2CAN060901

**SUBJECT:** Response to Request for Additional Information for the  
Technical Specification Change to Modify RCS Flow Verification  
Arkansas Nuclear One, Unit 2  
Docket No. 50-368  
License No. NPF-6

**Attachment to  
2CAN060901  
Response to RAI**

Figure 1: ANO-2 Reactor Coolant Pump Differential Pressures

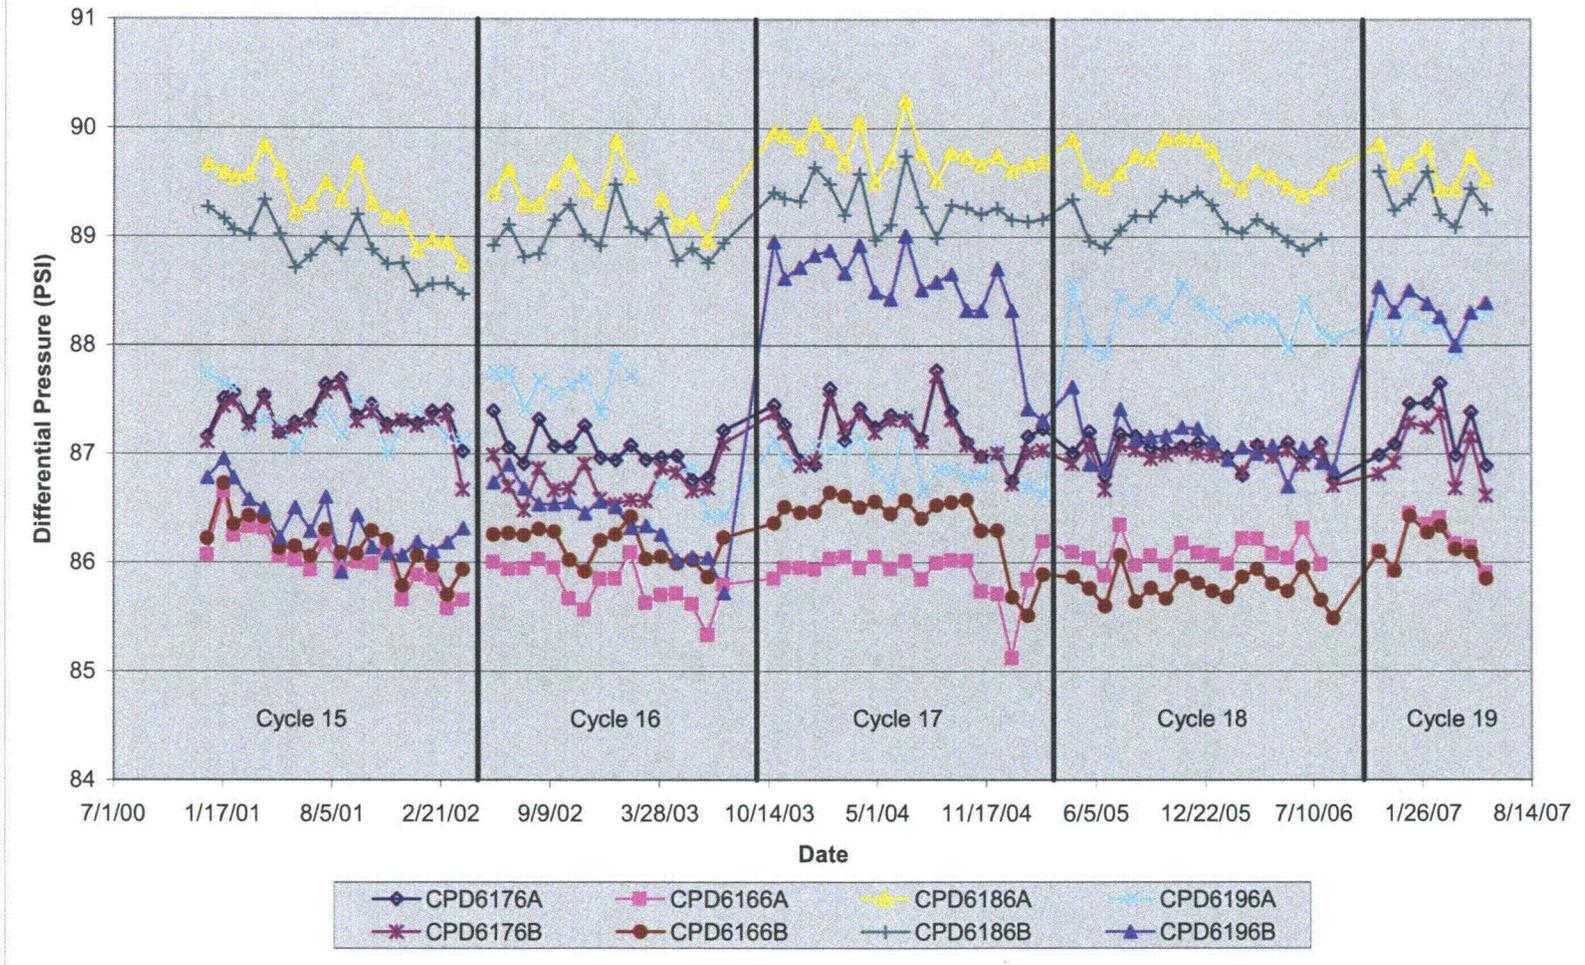
- (b) Justify that the validation performed for ANO-2 is adequate to support the licensee's claim that the COLSS indicated flow can be used as a wholly independent calibration standard over the entire operating temperature and pressure range for an extended period of RCP operating time. In addition, the licensee should satisfactorily address the following concerns - (i) the COLSS indicated flow rate is determined using the RCP head curves, which are developed on a specific testing configuration, temperature and pressure condition. The RCP curves may be changes for plant configurations,**

The relative stability of RCP ΔP instrumentation over time is shown in Figure 1. Although the data does show evidence of instrument calibration errors, there is no indication of degrading pump performance. As part of the analyses performed to support the proposed change, surveillance criteria have been established to ensure calibration errors or instrumentation problems are detected and addressed. Sensitivity analyses have been performed to establish penalties for instrument deviations that will ensure a conservative pump ΔP flow rate.

With respect to pump degradation over time, there is no evidence that this is occurring to any significant degree. The detailed trends of pump  $\Delta P$  instruments shown in Figure 1 provide no trend indicative of degradation over time. As previously discussed in the response to RAI 1.b, Table 1 shows restoration of the flow rate following installation of RSGs to a level matching or exceeding the plant's original flow rate. The back calculation of hot leg temperature described in response to RAI 2.a also provides evidence that any degradation that has occurred is not significant.

**Figure 2: ANO-2 Cycle 15 Loop A Hot Leg Temperatures**  
Hot Full Power Data

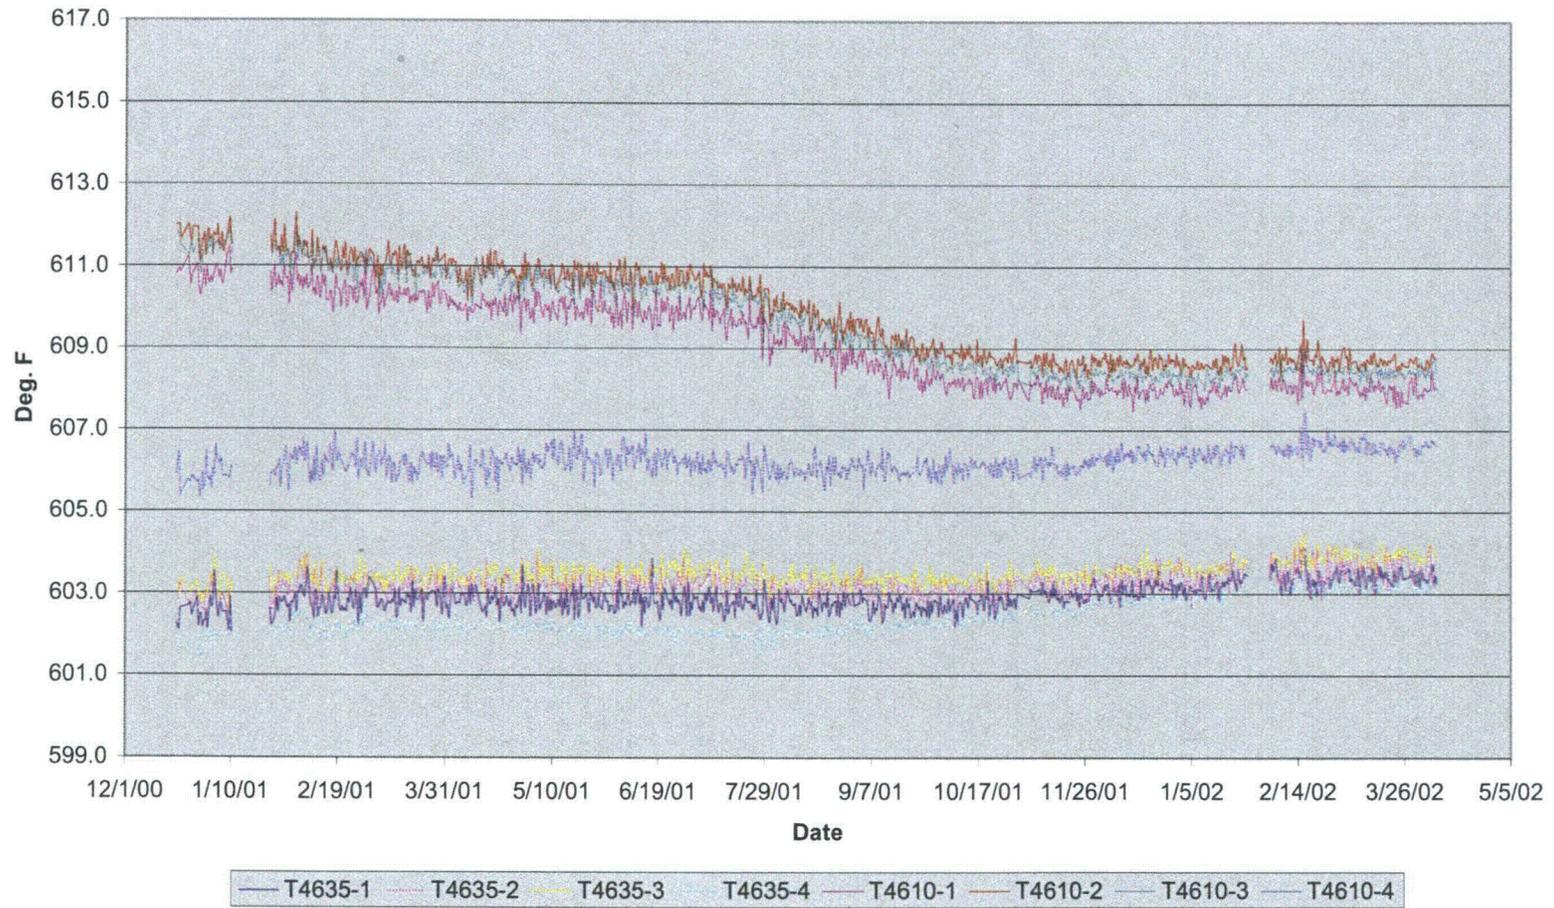
- (b) Provide a discussion with applicable temperature measurement data to substantiate the claim that the calorimetric measured flow rate is “overly” conservative as compared with the COLSS indicated flow rate. The information should include a typical set of hot-leg temperature measurements that show temperature stratification, and a discussion to distinguish effects of uncertainties of RCS hot-leg temperature measurements and temperature stratification phenomena on the calorimetric flow rate determination. Also, quantify the conservatism in terms of a power level reduction in meeting the safety limit DNBR at a lowest value of the measured calorimetric flow rate.**

Figures 2 and 3 show the stratification in Loop A and B hot legs during Cycle 15. Figure 4 provides an indication (excore raw signals) of the radial power distribution shift from the inside of the core to the outside of the core over the course of Cycle 15. Comparison of the trend in Figure 4 to Figures 2 and 3 clearly shows the influence that radial power distribution has on hot leg stratification. Further evidence of this connection is provided for Cycle 20 (the currently operating cycle) in Figures 5 through 7.

average temperature. As Figures 2, 3, 5 and 6 show, the most variation occurs in the hottest indications. A higher than actual average temperature is conservative with respect to calculating the flow rate. None of this is meant to say that the hot leg temperature instrumentation is meaningless or that the instrumentation can not be used conservatively, only that the accuracy and precision required for calorimetric flow calculations is not present.

**Figure 8: Indicated Temperature vs. Instrument Location**  
(Cycle 15 Example Shown)

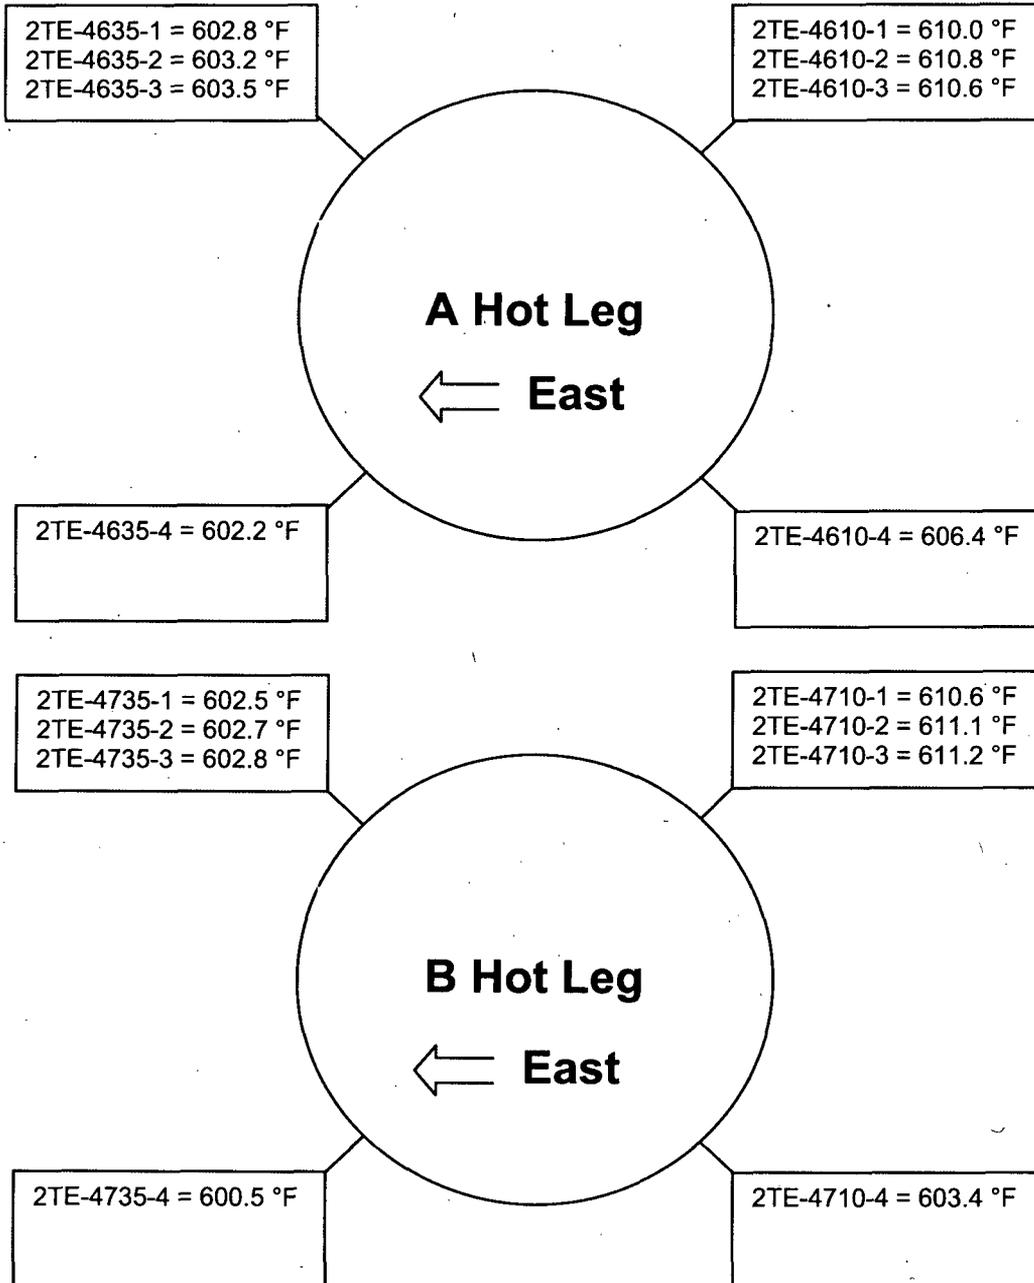
1. **Paragraph 4 on page 2 to Attachment 1 of letter dated November 13, 2008, indicates that the calorimetric method can be susceptible to the effects of temperature stratification of fluid in the reactor coolant system (RCS) hot-leg. It claims that these effects will result in calorimetric flow measurements being overly conservative as compared with the COLSS indicated flow rate.**
  - (a) **Discuss the RCS hot-leg temperature measurements that are used for determining the calorimetric flow rate. The information should include a discussion of locations and numbers of temperature probes for hot-leg temperature measurements, and method of the hot-leg temperature determination.**

The RCS hot-leg temperature instruments currently used in the calorimetric determination of flow consist of eight temperature elements on each hot leg (for a total of sixteen temperature elements). The eight temperature elements on each hot leg are arranged in pairs of two, with the two forming the pair being 90 degrees apart along the circumference of the pipe. On each hot leg, three instrument pairs are positioned on the top half of the pipe and one instrument pair is positioned on the bottom half of the pipe. The pairs on the top half of the pipe have elements approximately 45 degrees to the left and right of the top of the pipe. The single pair on the bottom of each hot leg pipe similarly has elements approximately 45 degrees to the left and right of the bottom. Figure 8 provides an illustration of the arrangement.

Figure 8 is included to illustrate typical temperature readings in relation to instrument location on the hot leg piping. Considering the depth of the thermowell penetration in relation to the diameter of the hot leg piping, the difference in measured temperatures at different locations around the pipe (high temperatures in one particular quadrant of each hot leg) implies that the bulk average temperature can not be reliably inferred. There is no firm basis to assume any given indication is higher or lower than the true bulk average. However, since the true bulk average hot leg temperature is expected to be constant during operation at a constant power level, indications that vary more over the course of a cycle than others are likely to be the least indicative of the real
